Duane Arnold Energy Center
Docket No. 50-331
Renewed Facility Operating License No. DPR-49

NextEra Energy Duane Arnold, LLC's Six-Month Status Report in Response to June 6, 2013 Commission Order Modifying Licenses with Regard to Reliable Hardened Containment Vents Capable of Operation Under Severe Accident Conditions (Order Number EA-13-109)

NextEra Energy Duane Arnold, LLC's Six-Month Status Report in Response to
June 6, 2013 Commission Order Modifying Licenses with Regard to Reliable Hardened
Containment Vents Capable of Operation Under Severe Accident Conditions
(Order Number EA-13-109)

Attachment A – Updated Layout of Proposed HCVS

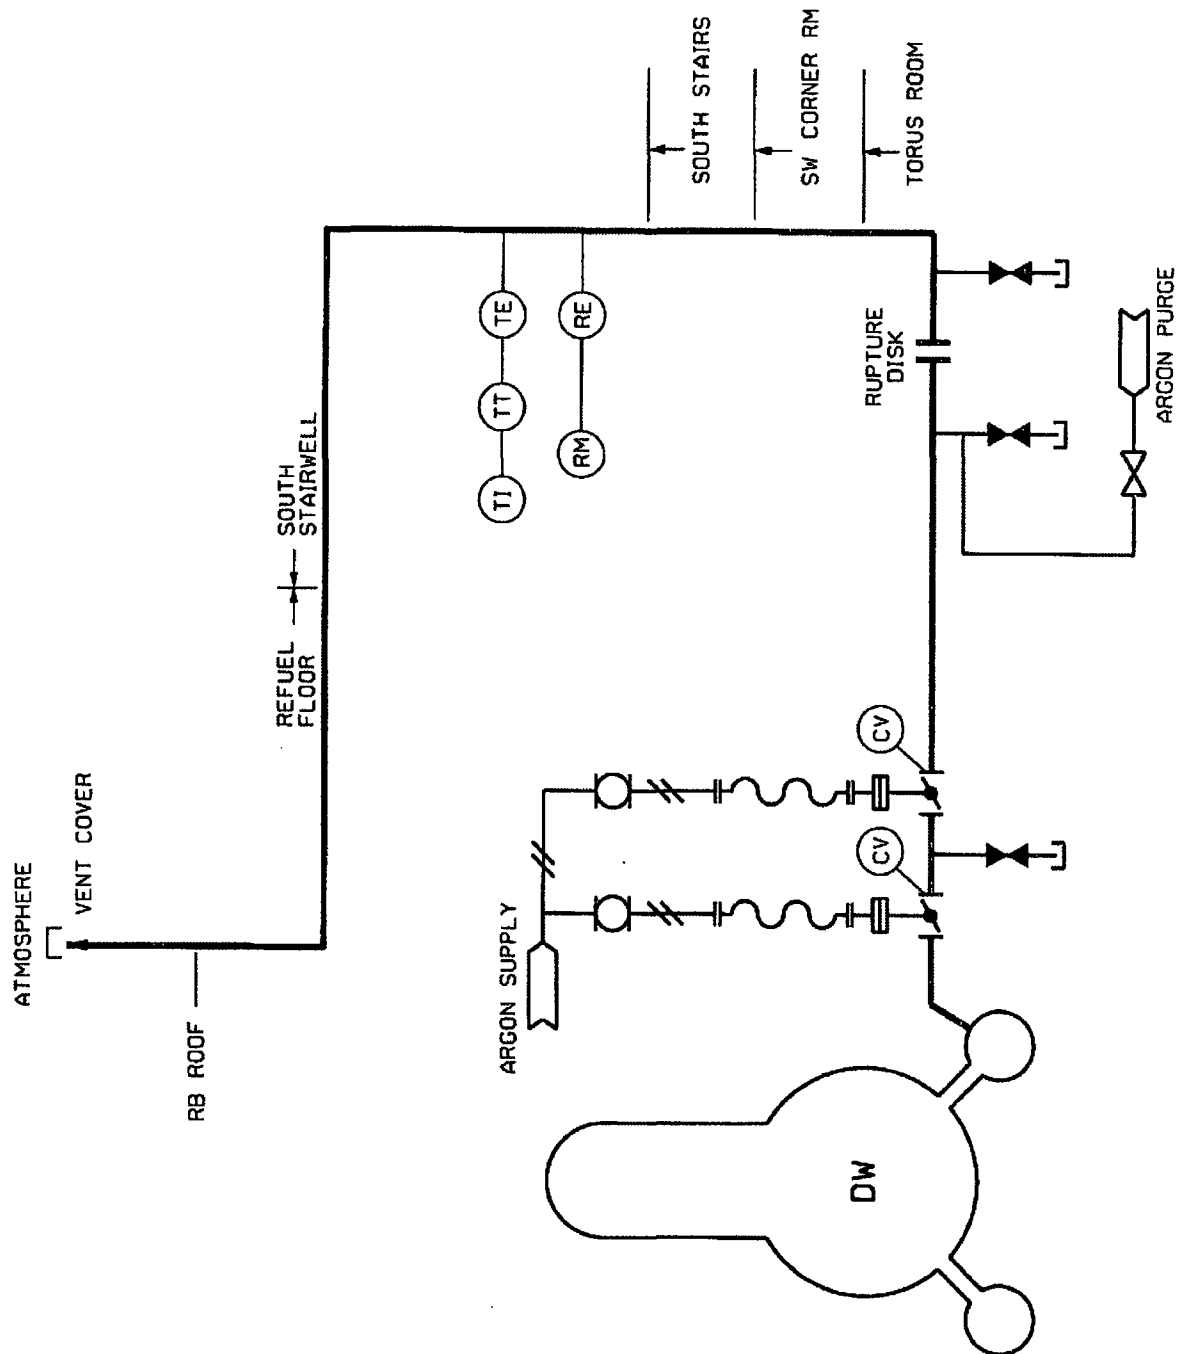
- 2) The routing of the new containment hardened vent system (HCVS) piping has changed from utilizing an existing containment penetration that supports normal venting to the Standby Gas Treatment System to using an existing spare penetration off the suppression pool. The vent piping will be routed into the south reactor building stairwell, up to the refuel floor and out the reactor building roof, reference Attachment A.

- 3) The HCVS piping will contain two new primary containment isolation valves and a new rupture disk as shown in Attachment A.
- 4) Attachment B is an updated listing of the HCVS instrumentation. It should be noted that the Interim Staff Evaluation (ISE) inadvertently listed a vent pipe process pressure indicator which will not be part of the Duane Arnold design.
